Minutes

Planning Committee

Wednesday 5 April 2023 6pm

Figure 2 - Building Height

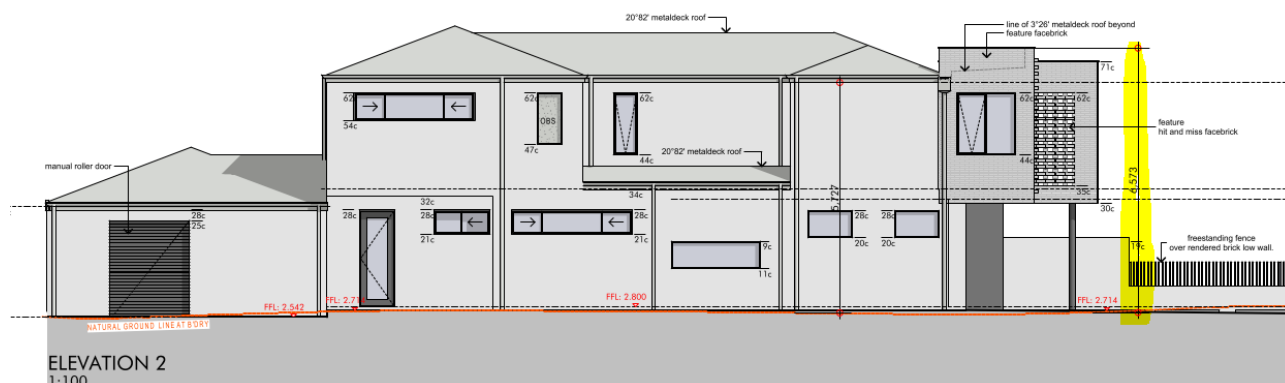
The building height is considered to meet the Design principles of the R-Codes in the following ways:

- The building height variation does not create an adverse amenity impact on the adjoining properties or the streetscape because the majority of the building has a height of 5.7 metres, being a minor departure from the requirements under Schedule 7 of LPS4, and with a minor concealed roof portion at the front of the property reaching a maximum of 6.537m (refer to figure 2 below).
- The building height variation maintains access to views of significance, and adequate access to direct sun into buildings and open spaces on adjoining properties.

Figure 3 - Extent of Cone of Vision variation (shown hashed in red)

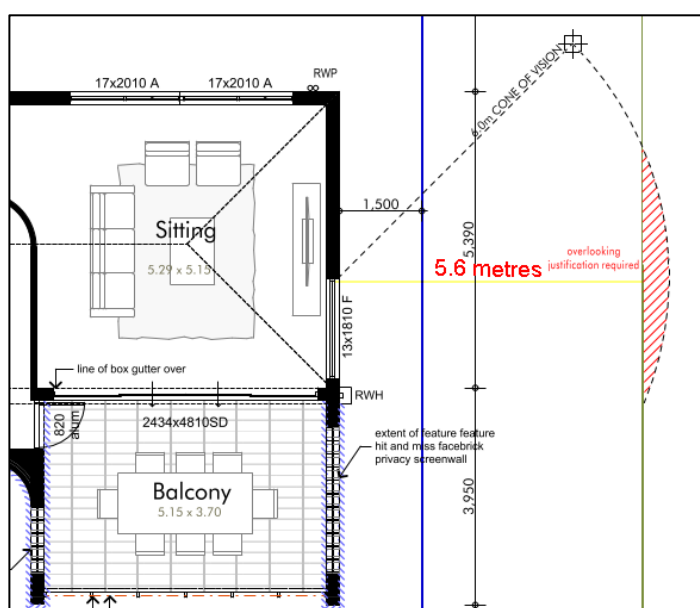
The visual privacy is considered to meet the Design principles of the R-Codes in the following ways:

- The visual privacy cone of vision variation does not impact on any primary outdoor living areas of the adjoining site.
- The cone of vision does not unreasonable impact on the privacy to major openings on the adjoining site
- The lesser cone of vision setback is otherwise considered to represent only a minor departure from the deemed-to-comply requirements (400mm difference); and noting the majority of the cone of vision overlooks the common property access leg (refer to figure 3 below) and side and front setback area of this residential property.

Figure 3 – Predominant lesser street setback along Ainslie Road.

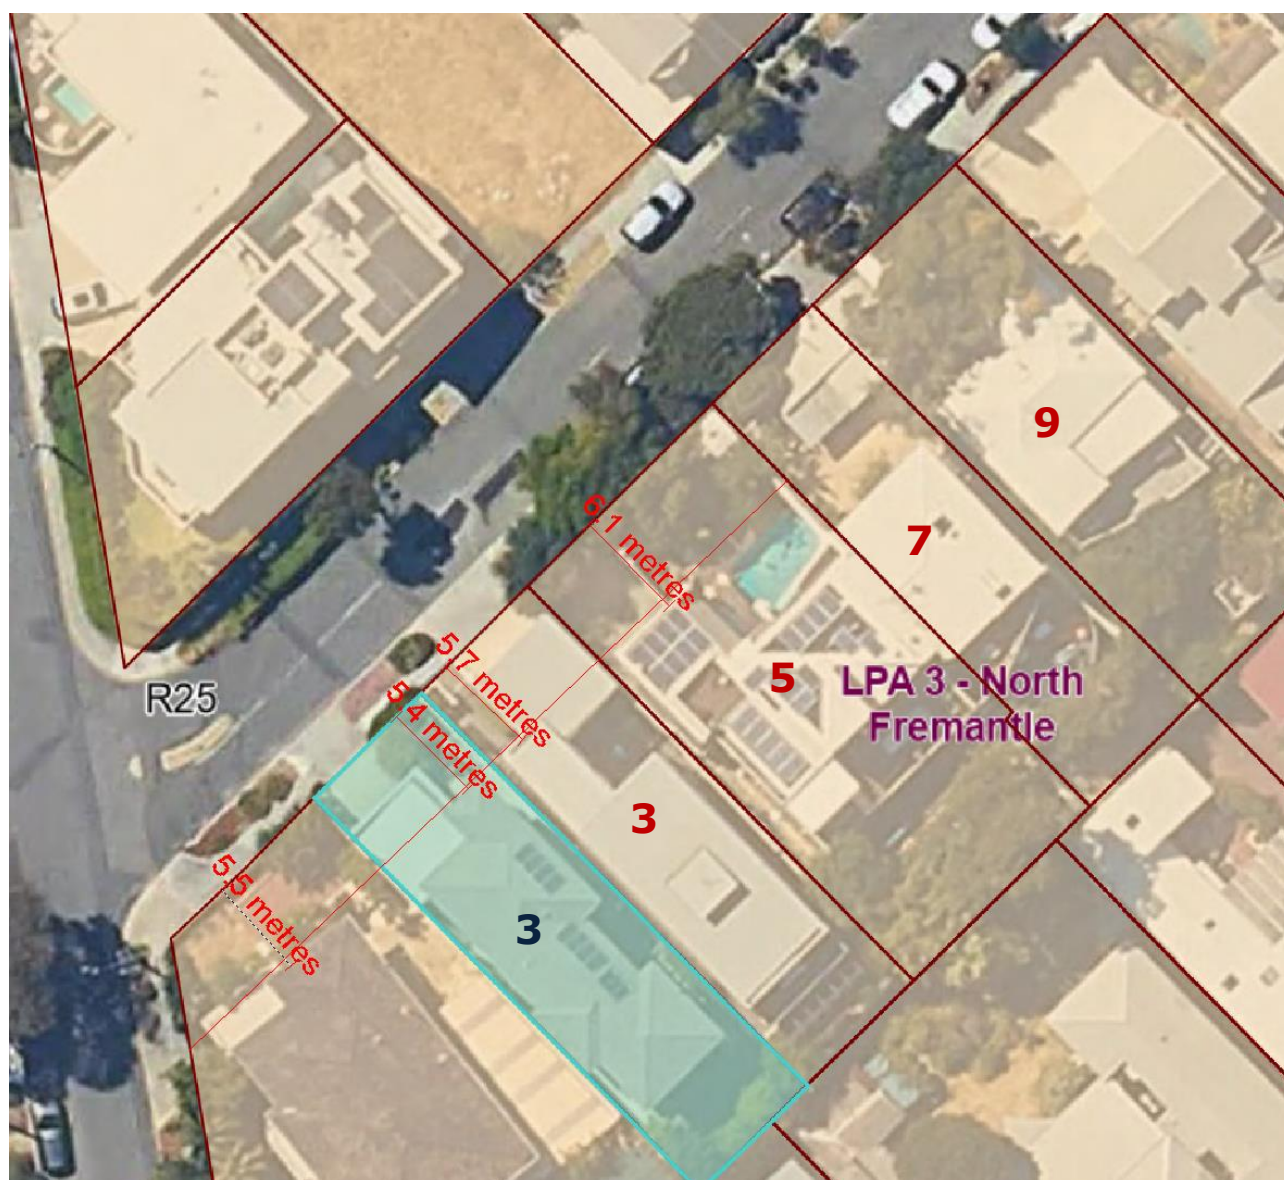
- The existing street setback of the subject site already contains a minor variation (3m in lieu of 5m) from that of the primary street setback requirements for North Fremantle set out in LPP 2.9. Therefore, the alterations are simply enclosing the existing carport with no extension or change in size to the existing structure, to be provided with a roller garage door.
- The topography of the block allows the height and visual mass of the proposed garage to be reduced as viewed from the street, due to the natural ground level and will allow the garage to sit slightly below the level of the street.

- The overall style of the proposed garage addition is consistent with the setback of buildings in the existing streetscape and adjoining properties to 3A Ainslie Road (see Figure 3 below). Therefore, the reduced setback to the proposed garage addition would not detract from the existing streetscape – which already features properties with reduced setbacks including 3B, 5, 7 and 9 Ainslie Road (see figure 3).

On the basis of the above, the proposed ground floor street setback from the garage is considered acceptable and supportable under Clause 1.2 of LPP 2.9.

Figure 6 – Lot boundary setback – impact on Western adjoining property (2 Rule Street).

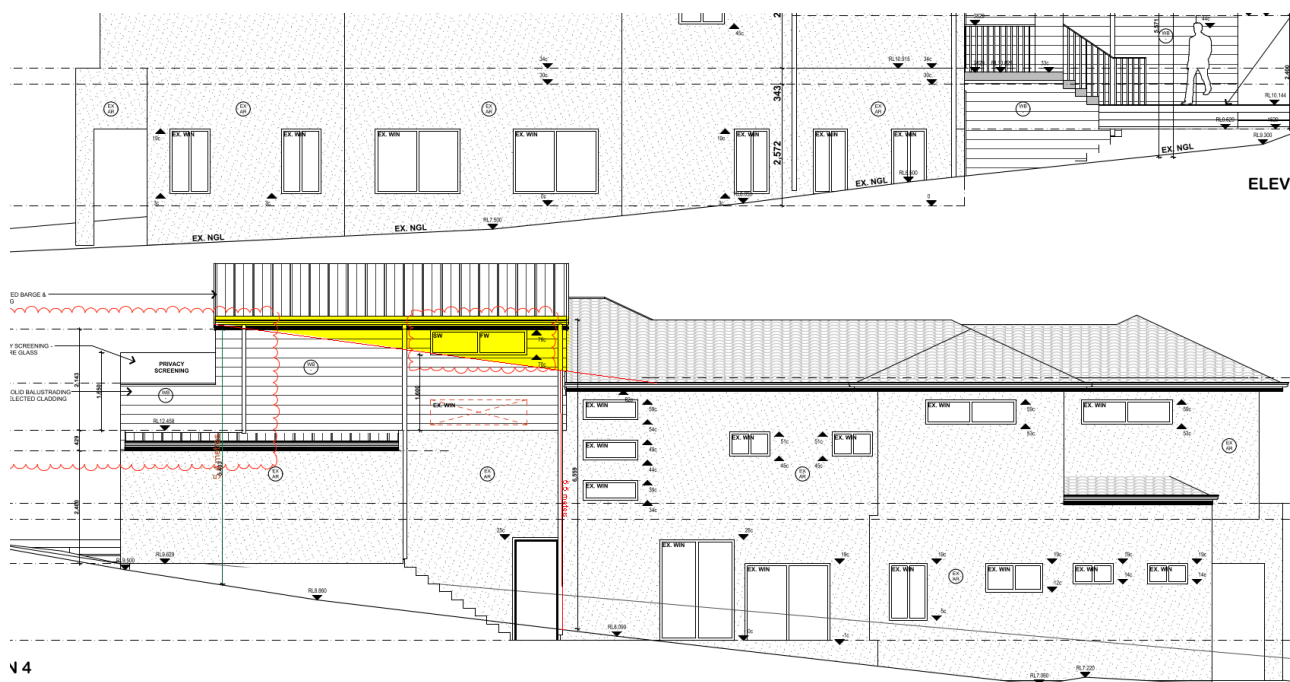
Element	Requirement	Proposed	Extent of Variation
Building height – Local Planning Scheme No. 4 LPA3 – North Fremantle	5.5m external wall height	5.4m - 6.5m	Up to 1.0m

The portion of the proposed development which seeks the wall height discretion is shown below in yellow.

The proposal varies the maximum permissible building height prescribed by the North Fremantle Local Planning Area LPS4 provisions. As such the additional building height needs to be assessed under the discretionary criteria of clause 4.8.1 (variation to height requirements), which are as follows:

Figure 7 – Overshadowing diagram and impact on southern adjoining property.

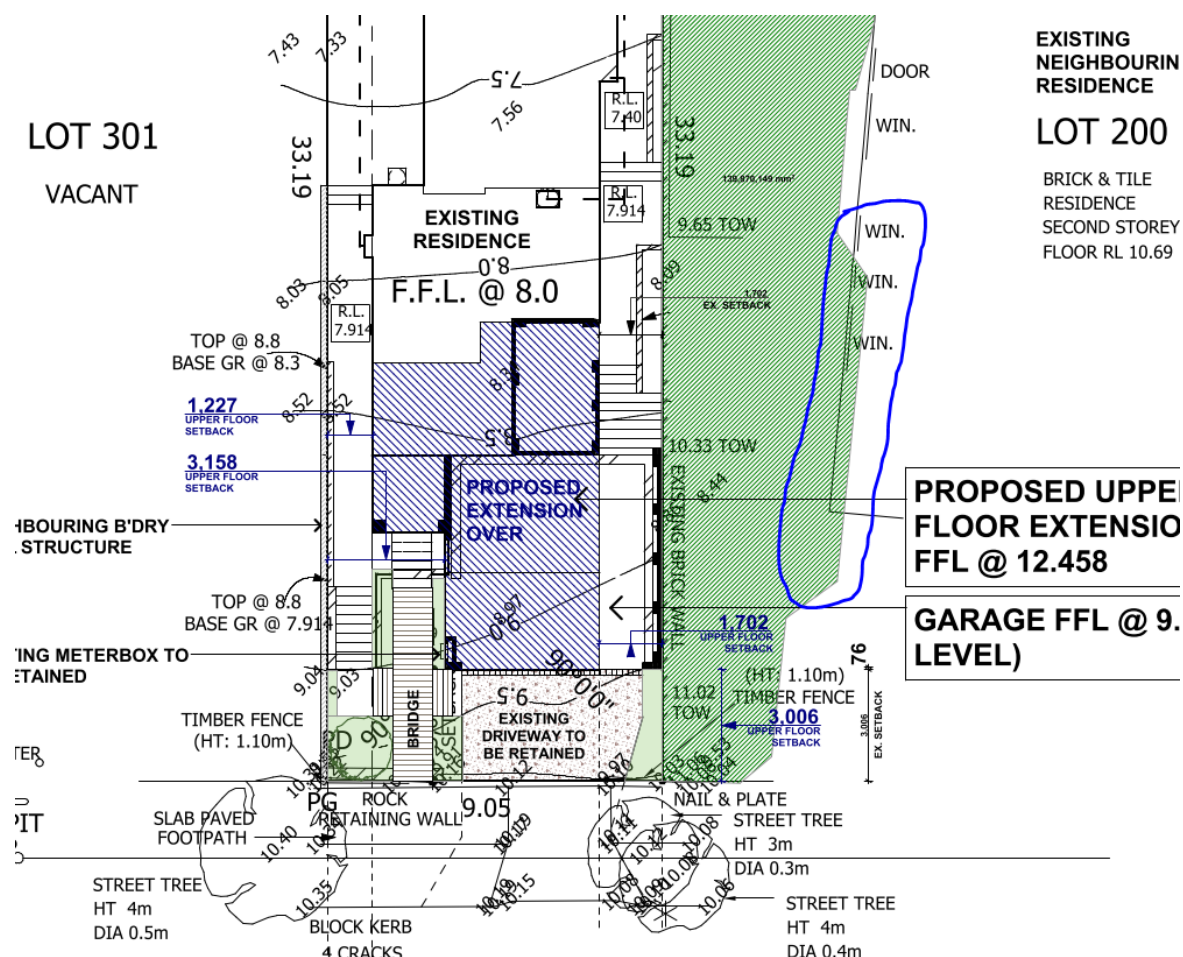
With regards to subclause (a), the proposed upper floor addition is located so as to limit the extent of overshadowing owing to the adjoining neighbour to the west and meets the deemed-to-comply criteria of the R-codes for the overshadowing of adjoining sites. The extent of overshadowing to the southern adjoining property is demonstrated in Figure 7 (see blue circle) showing a minimal impact on the major openings.

Figure 1. Aerial Image showing Hickory Street Streetscape

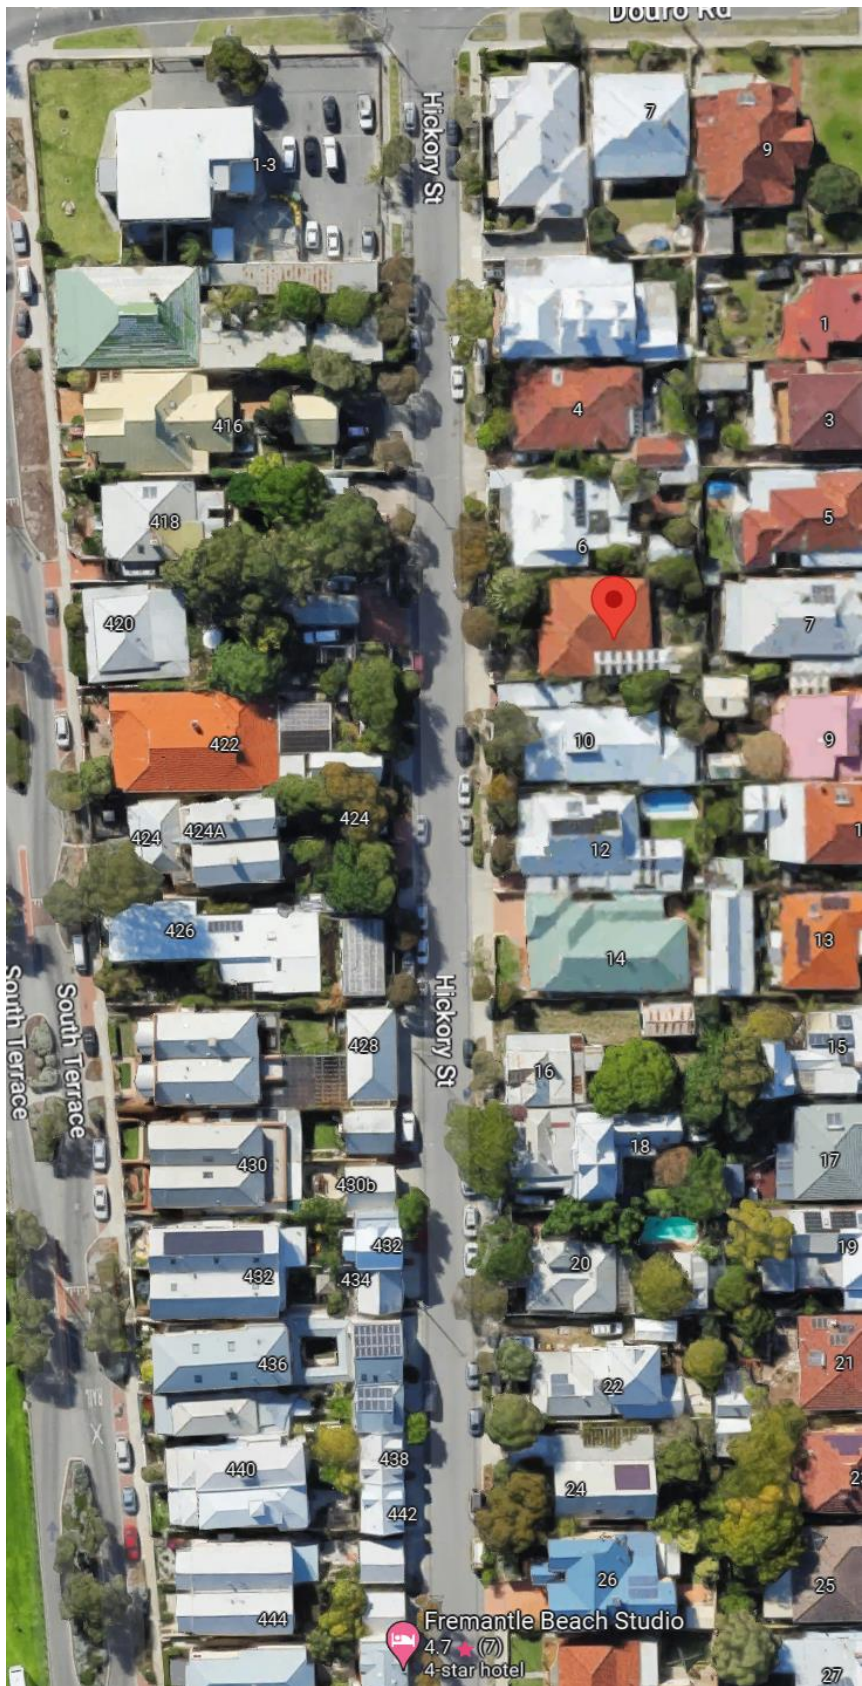
The first-floor primary street setback variation of 0.57m from the required 10m setback required by LPP2.9 (Residential Streetscape) is supported on the following basis:

- The Hickory Street streetscape is of a highly varied and inconsistent nature with no prevailing character. The western side of Hickory Street is characterised by the rear of properties fronting South Terrace and includes development built right up to the Hickory Street frontage of these lots. The western side of Hickory Street is characterised by one and two-storey single houses with varied setbacks from Hickory Street (refer aerial image below). As such, the minor variation to the street setback of the 1st floor does not have an adverse impact upon the streetscape character of Hickory Street.

Figure 3. Amended Plans Overshadowing Assessment, plans dated 3 March 2023.

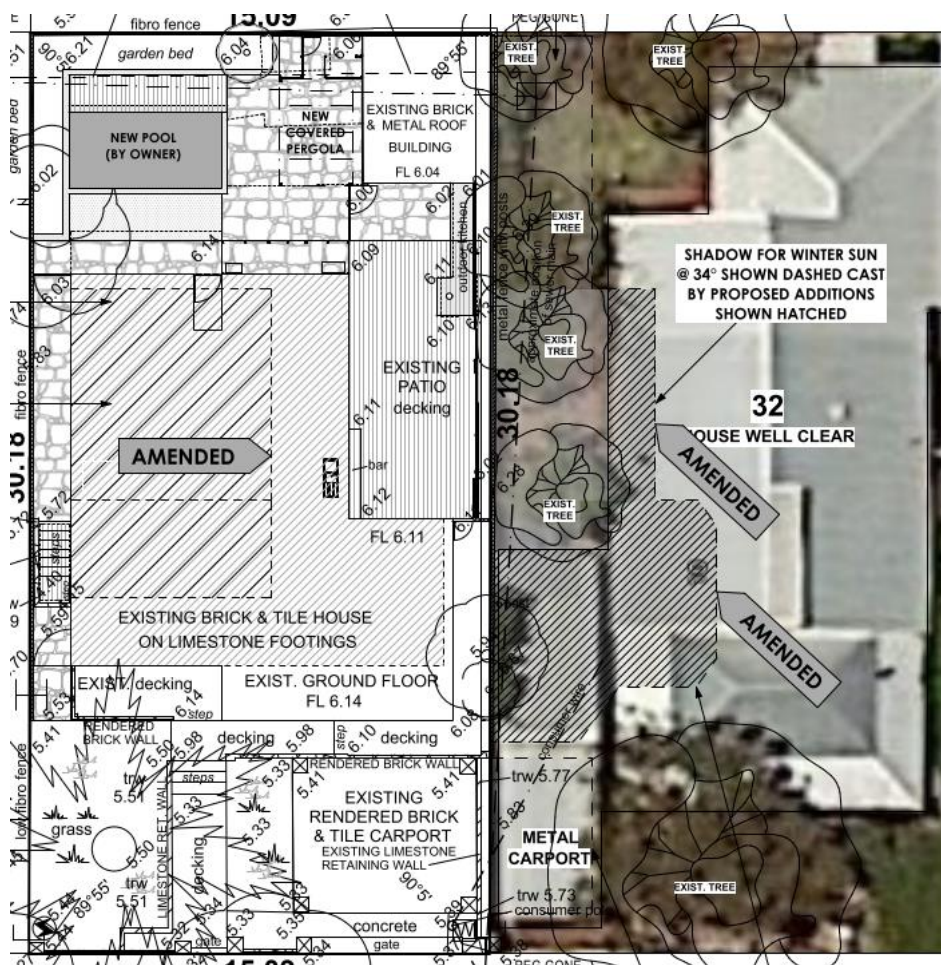
On the basis of the amended development plans, dated 3 March 2023, the overshadowing of the adjoining southern lot (No. 10 Hickory Street) is considered to meet the Design principles of the R-Codes, for the following reasons:

- Importantly, the extent of overshadowing of outdoor living areas and habitable room windows has been partly reduced and given the overshadowing is assessed under the worst-case scenario (winter solstice), it is expected that the overshadowing impacts upon outdoor living areas and habitable room windows will be acceptable under the amended development proposals.

- It is also important to note that on east-west orientated lots such as those on Hickory Street, with lot widths of 15m, some overshadowing is generally inevitable for development proposals above a single storey. The shadow impact of the proposal has clearly informed the overall design of the amended proposals with all southern lot boundary setbacks achieving or greatly exceeding (in the case of the third (roof terrace) level) the deemed-to-comply requirements of the R-Codes and shadow impact of the proposal has been effectively mitigated as a result.

Figure 1: Sun Angle to southern adjoining property (3 Collick Street) from proposed outbuilding and view toward existing patio deck at southern adjoining property.

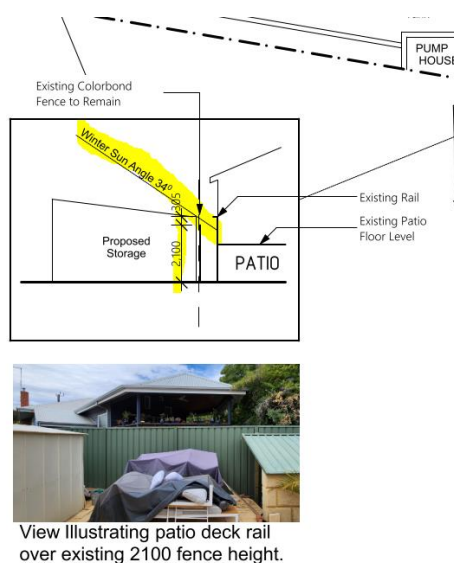
- A revised overshadowing diagram was provided which demonstrated the actual shadow impacts created by the proposed boundary wall on the existing outdoor living area of the adjoining southern property, (see Figure 1 below).

I have amended the site plan and added a diagram illustrating the overshadow impacts to the neighbouring outdoor area I have not put a shadow diagram in the usual sense because the percentage of overshadowing is nowhere near an amount that has an impact on the block anyway and the issue is the concern about overshadowing a particular outdoor living space.

Figure 2: Sun Angle to southern adjoining property (3 Collick Street) from proposed outbuilding and view toward existing patio deck at southern adjoining property.

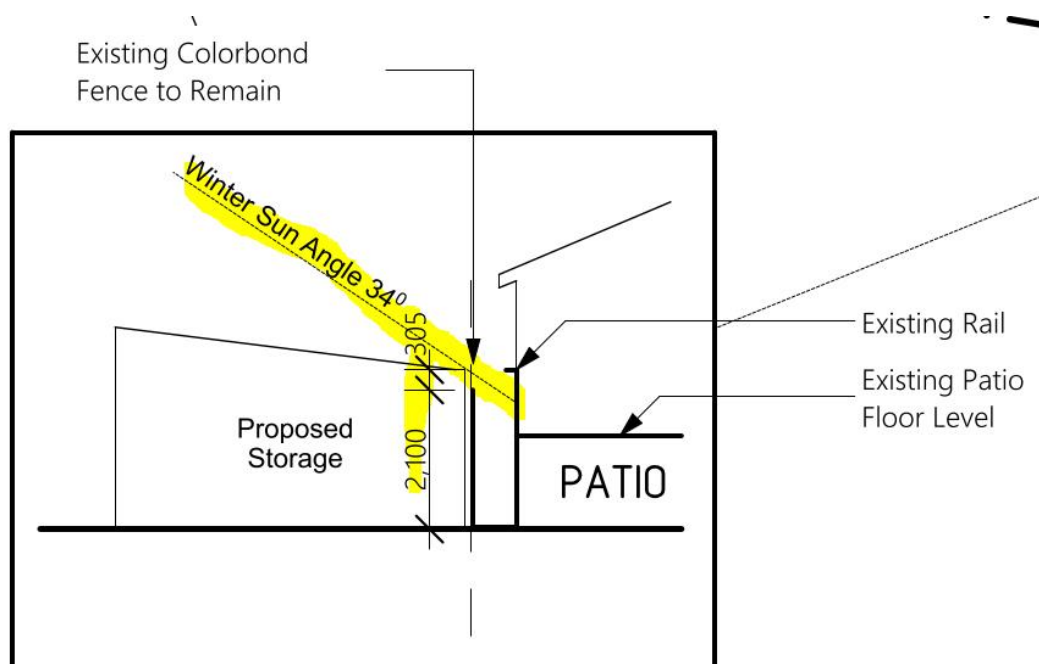
The outbuilding boundary wall is considered to meet the Design principles of the R-Codes in the following ways:

- The amended site plans demonstrate the proposed outbuilding, despite being located adjacent to a portion of the existing deck/ outdoor living area of the neighbouring property (3 Collick Street), will not result in a significant loss of sunlight owing to the existing adjoining patio being substantially raised above existing ground level, due to the topography of the subject site and low height of the proposed outbuilding wall above the existing boundary fence, being only an additional 300mm above the existing fence height (see Figure 2 below).

Figure 3: Front setback area of 3 Collick Street, where proposed Carport boundary wall will abut.

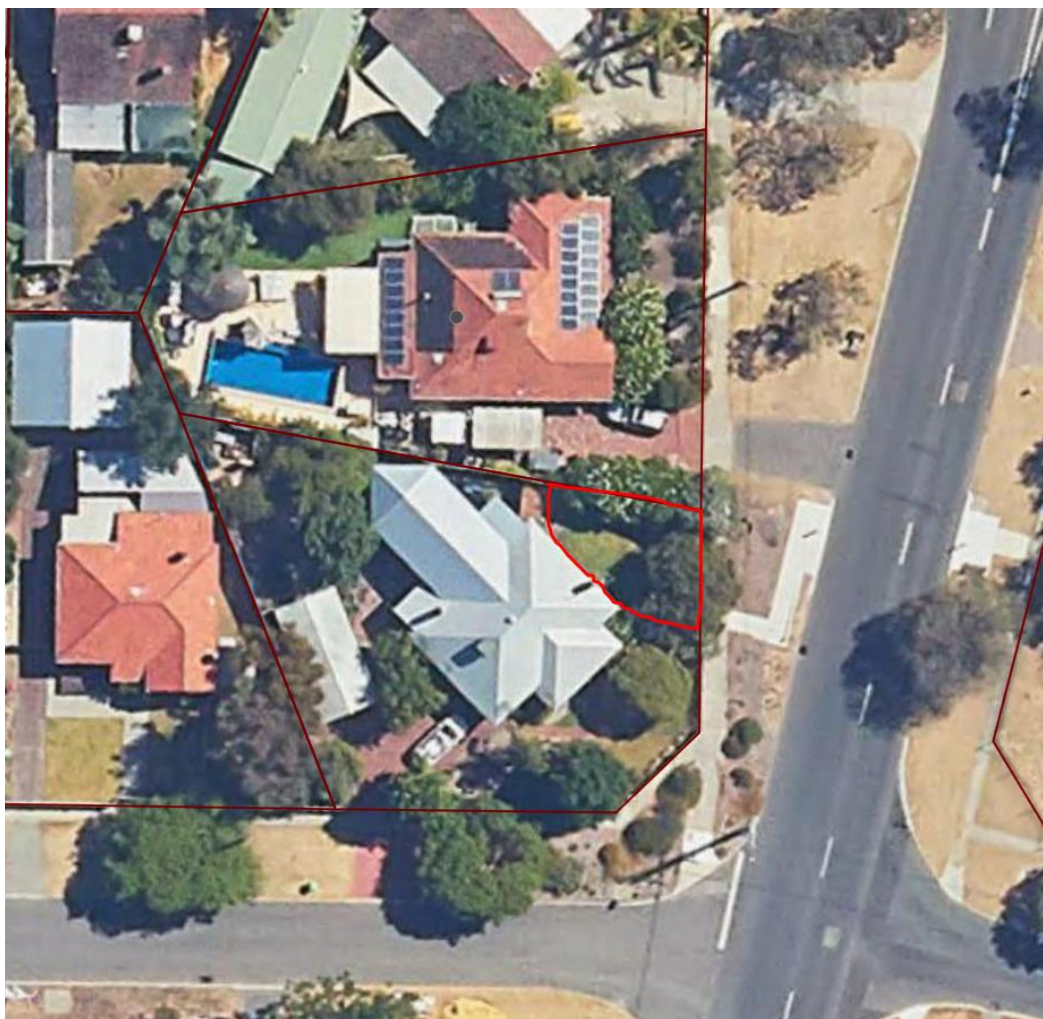
- The proposed boundary wall will be located adjacent to an area which doesn't form part of the neighbouring site's exclusive outdoor living area, nor in close proximity to sensitive habitable rooms of the respective dwelling. This area of the southern adjoining property is also heavily vegetated and within the front setback area. The boundary wall will not reduce any sunlight or ventilation to any habitable spaces or primary outdoor living areas on the southern adjoining property (see Figure 3 below).

- The boundary wall proposed essentially consists of a pillar and open design base, therefore having minimal impact upon the amenity of the adjoining property through a sense of building bulk.
